First beat: instrument identity and complete sequencer

R5 PROPOSAL / NOT FIRMWARE

The complete musical journey, with current strengths retained

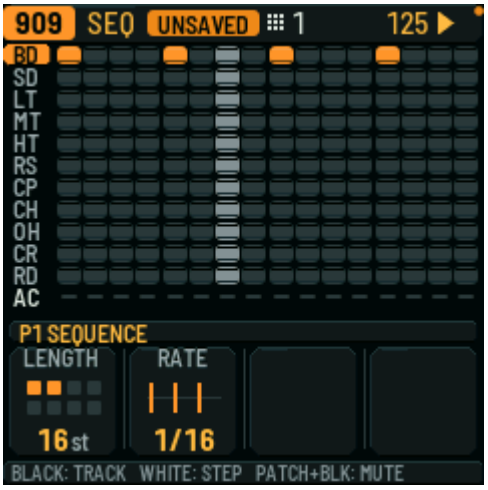
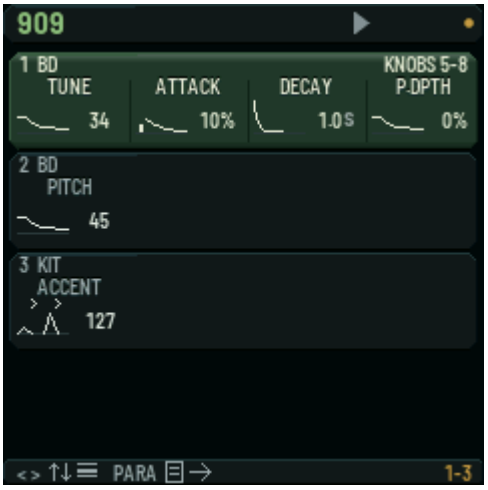
Change / reconsider Instrument pictures replace BD/SD abbreviations; unmapped lower cells show selected instrument. Power moves consistently to the compact top status.

Retain 11tracks plus accent,16columns, LENGTH/RATE, black-track selection, white/pad writing, PATCH+black mute and all useful lower controls.

Useful outcome Recognize the intended sound without a new selection page or losing step context.

Chicago: preserve native waveform and established ADSR family

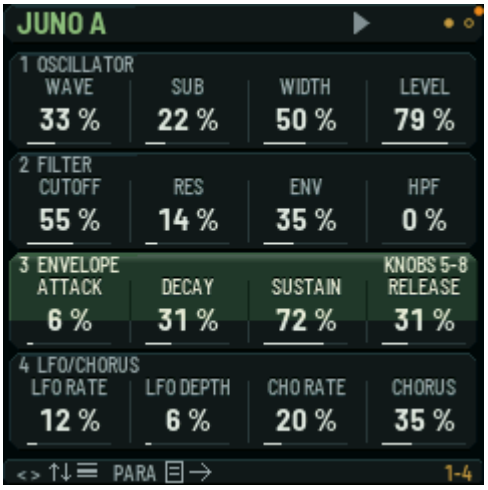
Change / reconsider The native one-cycle29 x 19 source oscillator projector replaces the rejected prototype sketch. Top status is common; there is no new bespoke ADSR design.

Retain Simultaneous groups, all sparse columns and SOUND/FX pages; existing full-row K5A/K6D/K7S/K8R labels and source ADSR layout; current engine/slot identity.

Useful outcome Consistent scope/value/cue ownership without discarding useful current native vocabulary.

Juno: preserve large values and fast parameter editing

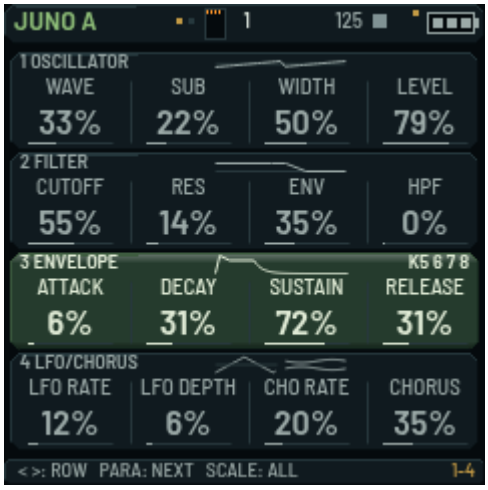
Change / reconsider Shared wave/filter/ADSR/LFO/effect-family thumbnails use only the row-heading gutter. The earlier proposal that shrank values or replaced the whole Juno ADSR row is rejected. The compact top status stays consistent.

Retain Existing large numeric readouts, labels, neutral bars, four columns, four neighboring groups plus SOUND,16 controls and remembered navigation.

Useful outcome Additional visual context must not reduce the legibility of the values a musician edits.
